Advertisement Questions

June 18, 2024

VDOT Project No.: 0011-102-728, P101, R201, C501, UPC 105309
Project Name: Lee Highway Widening – Phase 1B
Capital Project No.: 95735

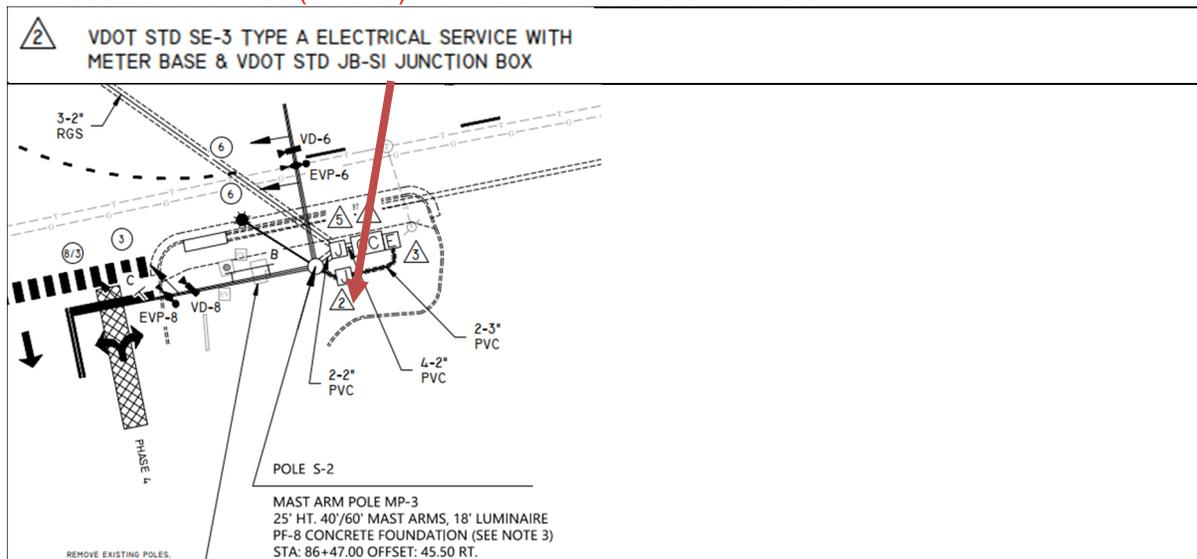
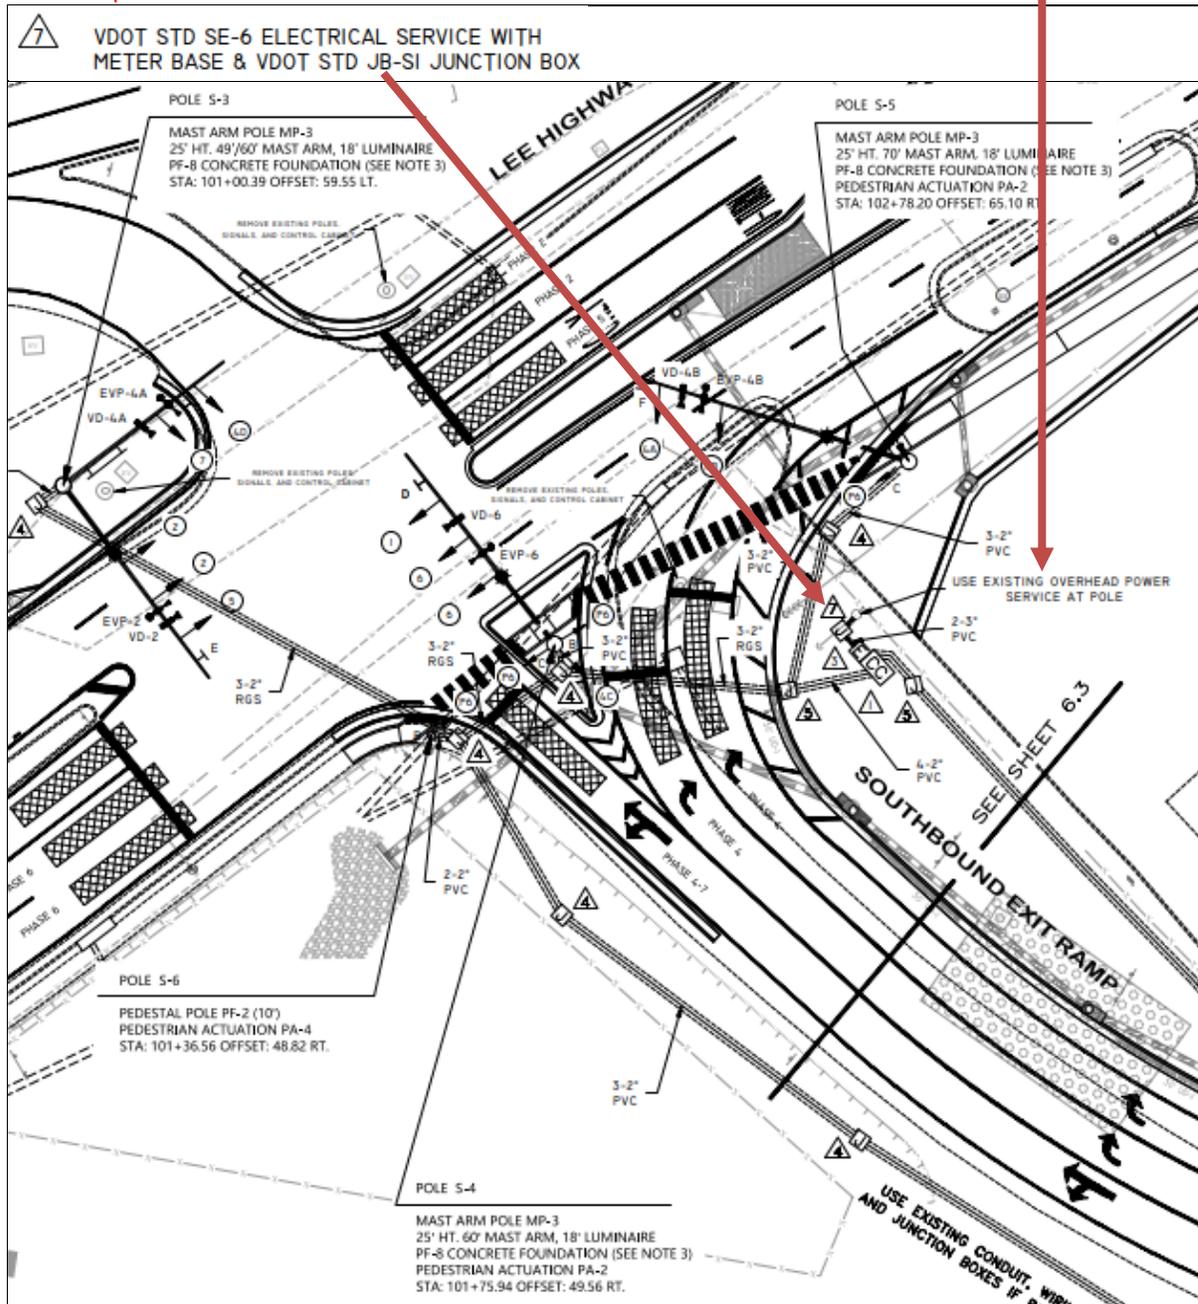
12. Please clarify the electrical service for bid item 1260(1), 1460(1), and 1470(1). Plan sheet 6.2 & 6.4 call for SE6's on them.

Item 1260 – Plan sheet 6.2 (Pole S-2) denotes 1 each Electrical service SE-3

Item 1460 – Plan sheet 6.3 (Poled S-3, S-4, and S-5) denotes 1 each Electrical service SE-6 using the existing overhead power service as main feed

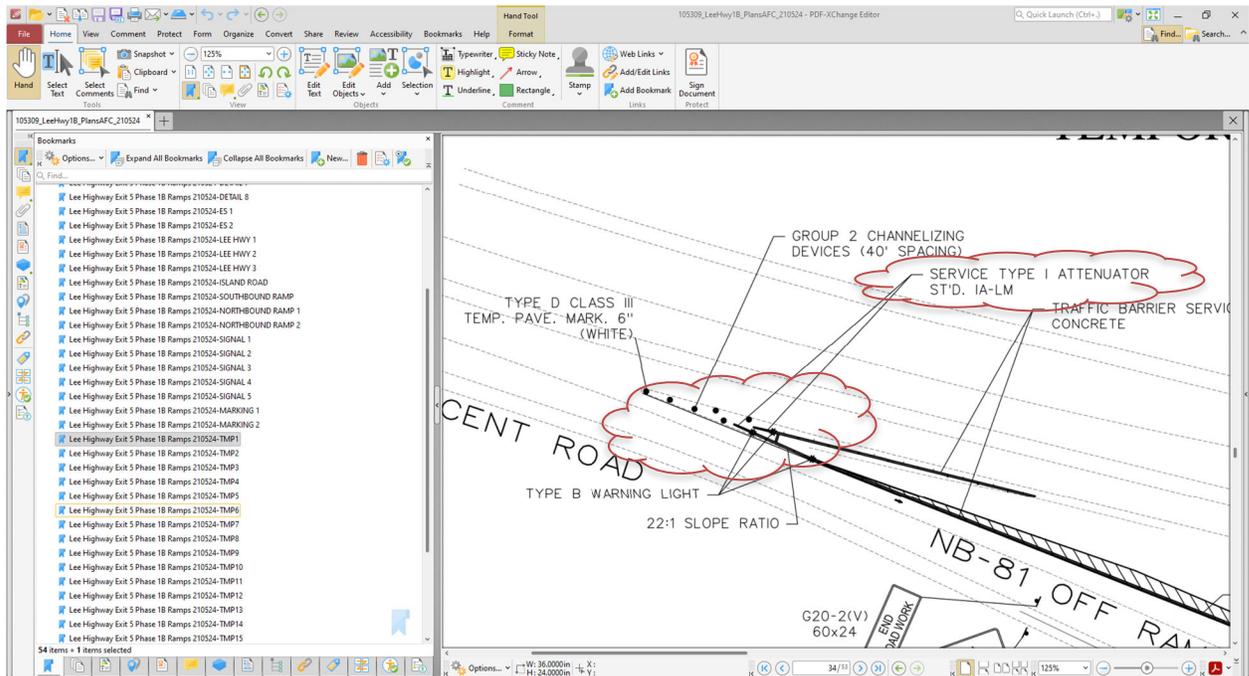
18. Line item# 1250 says to include hanger for ped head. Will this be a side of pole mount, top of pole mount.

Top of pole mount

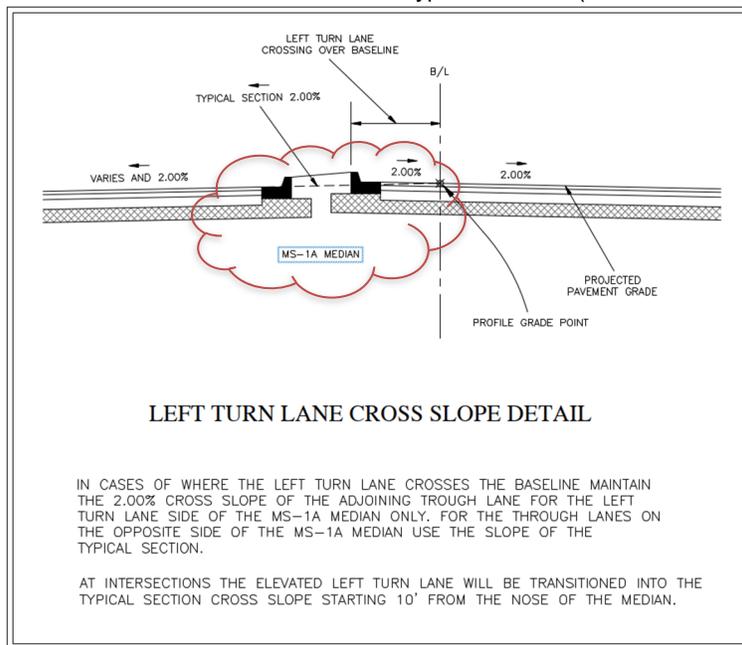
21. Line No. 470 (Item 21020 Median Strip MS-1)

This is denoted and delineated on the typical sections (Plan Sheet 3.4).
